A Performance Assessment Methodology for Low-Level Radioactive Waste Disposal Facilities

Recommendations of NRC's Performance
Assessment Working Group

U.S. Nuclear Regulatory Commission
Office of Nuclear Material Safety and Safeguards
Washington, DC 20555-0001

Manuscript Completed: October 2000
Date Published: October 2000

Figure 3. Section 3.1: Detail to the "Example of an Acceptable Process for Demonstrating Compliance with 10 CFR 61.41." The activities shown by the dotted lines depict the compliance review the NRC staff is expected to perform.

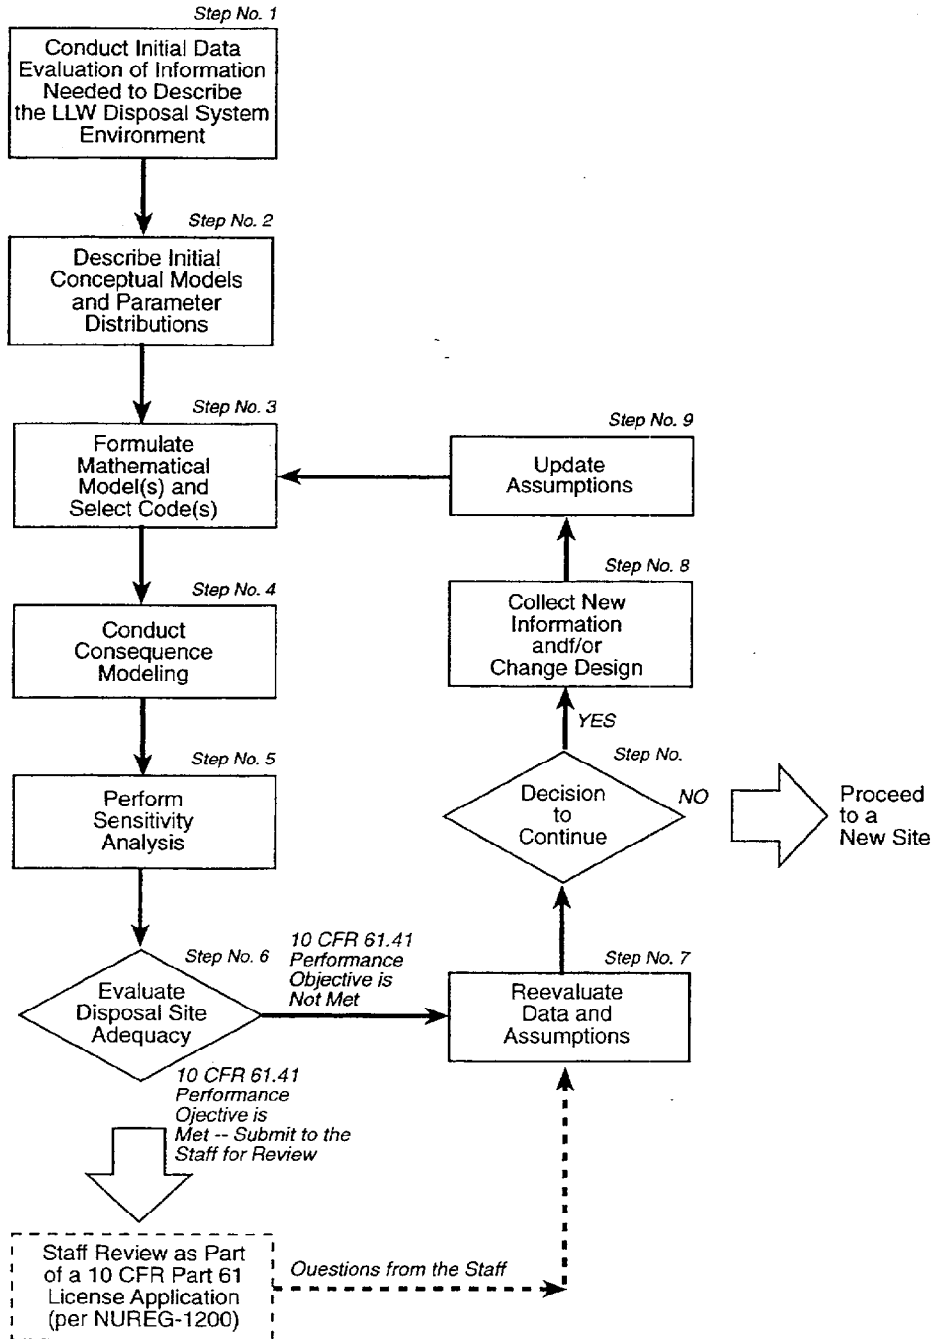
11. Page 3-2; "Branch Technical Positions (With Discussion)," Figure 3. Where does the option of limiting radionuclide inventory fit into this flow chart? Limits on radionuclide inventory may change a disposal site's rating from "inadequate" to "satisfactory."

7. Page 1-15, Paragraph 3. We strongly concur, and hope that the regulators are able to participate in such a process without compromising their objectivity. This might be indicated on Figure 3 [Technical Position 3.1: Detail to the "Example of an Acceptable process for Demonstrating Compliance with 10 CFR 61.41"], if appropriate.

In practice, the PAWG believes that the approach outlined in Section 3.1 of this technical report (and depicted in Figure 3) should result in a supportable demonstration of compliance with 10 CFR 61.41. *Step No. 6* of the process is the logical ending point for the required assessment; specifically, having

As noted in the response to *Golder Associates' General Comment No. 6*, the PAWG believes one of the tenants of good and effective regulation is to interact early and frequently with potential licensees. With this philosophy in mind, the NRC staff (or any other State regulatory authority) would, at the request of potential licensees, interact on any or all of the LLW performance assessment process steps described in Figure 3.

Figure 12. Conceptualization showing potential surface water contamination pathways. (All radionuclides distributed in the aquifer, in the vicinity of the surface-water body, are discharged into it.)

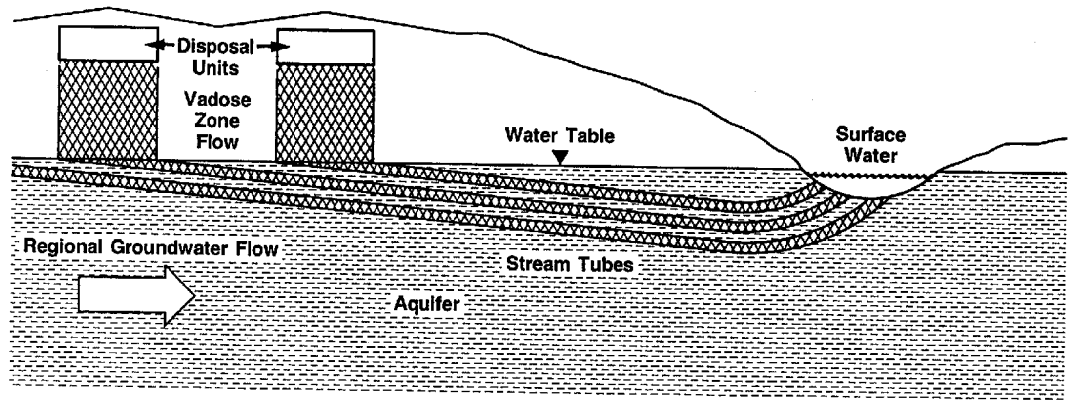
5. Section 3.3.6.2.1, "Surface Water. Considerations" (p. 3-61): The first sentence of this section references Figure 13. Figure 12 appears to be the more appropriate reference.

Figure 14. Example of potential dose pathways to be considered in an LLW performance assessment. [Determination of appropriate pathways depends on site-specific information (i.e., habits of the critical group). Adapted from EPA (1972).

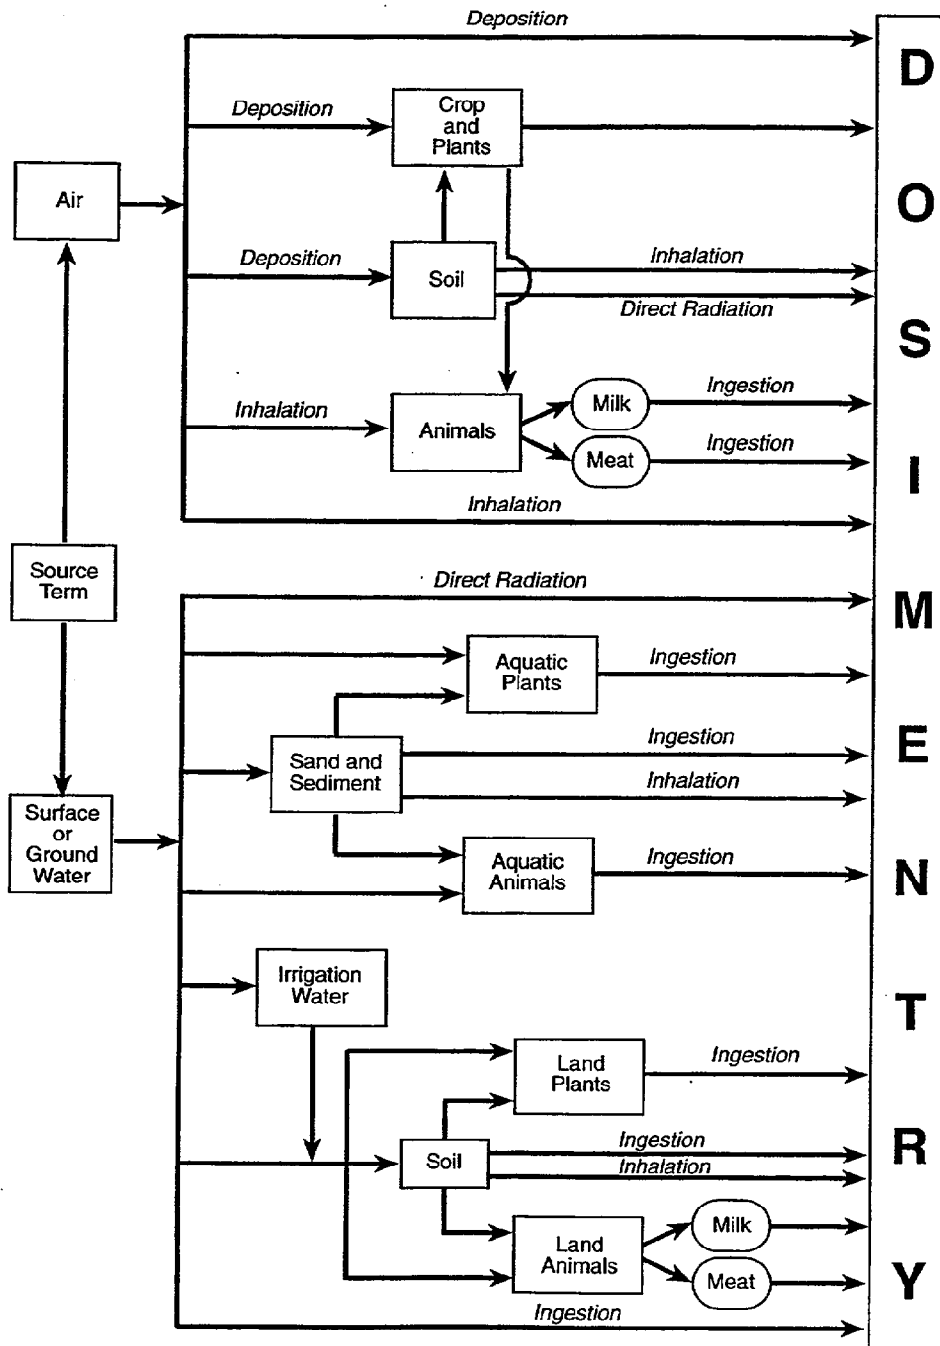
2. Page 3.75, Figure 14, this figure contains an unusual label [sic] "Fishing and Sports Gear." If this level of specificity was used uniformly throughout the diagram it may become too cluttered to be useful.

7. On Figure 14, the mechanism by which exposure is received by the individual (i.e., ingestion, inhalation, direct radiation) is identified in italics for some but not all of the pathways depicted. Specifically, the milk and meat pathways at the bottom of the figure should specify "ingestion," and the fishing and sports gear category and sand and sediments category should specify "direct radiation" if that is the intent.

The PAWG agrees with this comment. Figure 14 has been revised accordingly.

Figure 14 has been revised based on these comments.

Figure B-2. PAWG-recommended approach to calculating the peak of the mean dose.

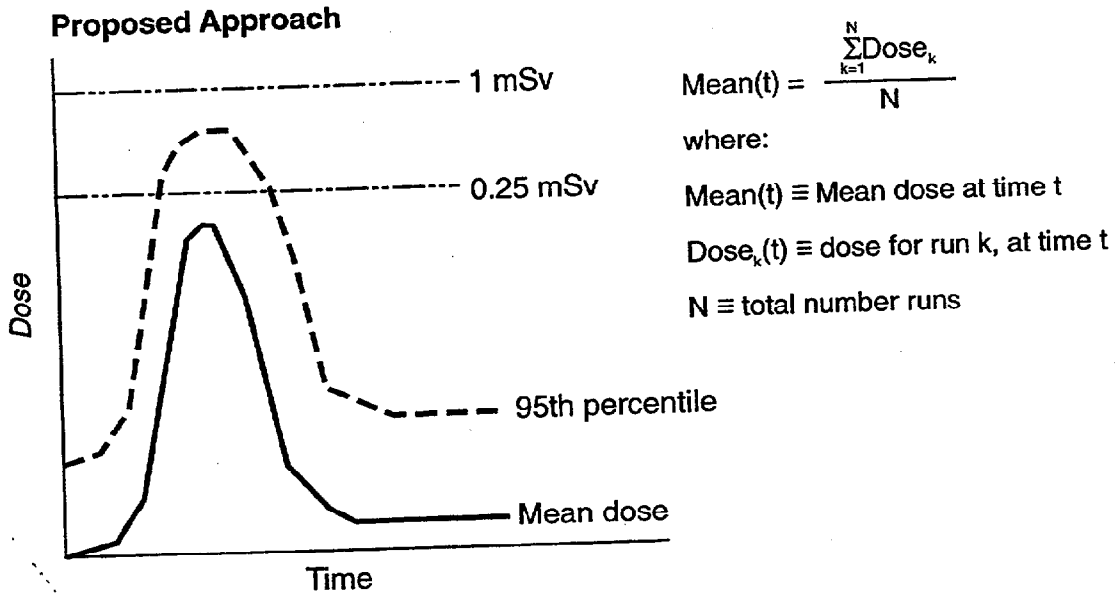
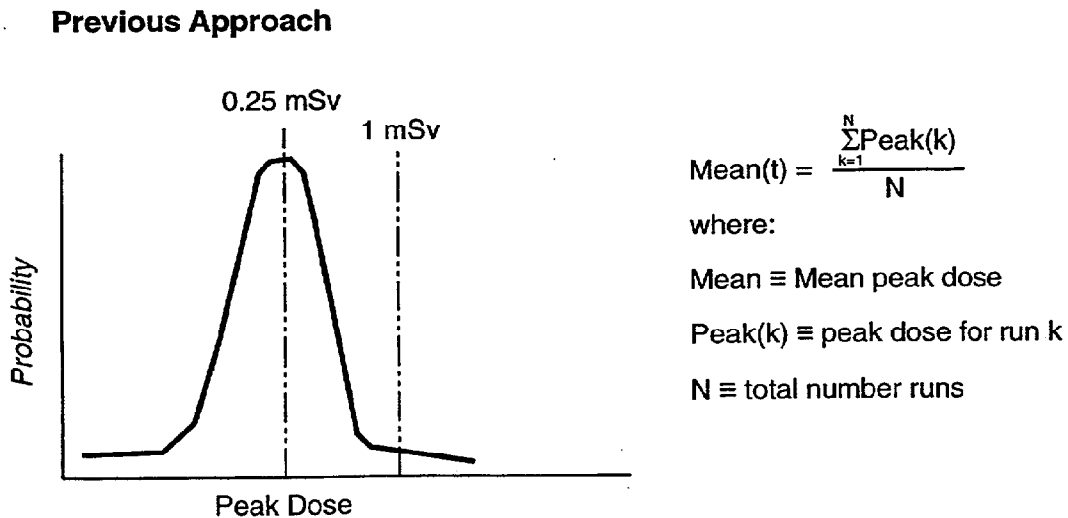
disposal system and is the most direct measure of risk. See Figure B-2. Further, placing a limit on the upper 95th percent confidence of the dose distribution provides additional assurance of the acceptable performance of the site – constraining the 95th percentile of the distribution to 1.0 milliSievert (mSv) [100 millirem (mrem)], as shown in Figure B-2. [In response to this and other comments, the PAWG staff have modified Paragraph No. 2 of Section 3.3.2.3.2 of this technical report (“Probabilistic Analysis”) to describe how the mean dose as a function of time can be derived mathematically, consistent with Item (a), shown in Figure B-2.]

(A) Current approach in the technical report. The following equation shows how the mean dose as a function of time can be derived. For N Monte Carlo realizations (or runs):
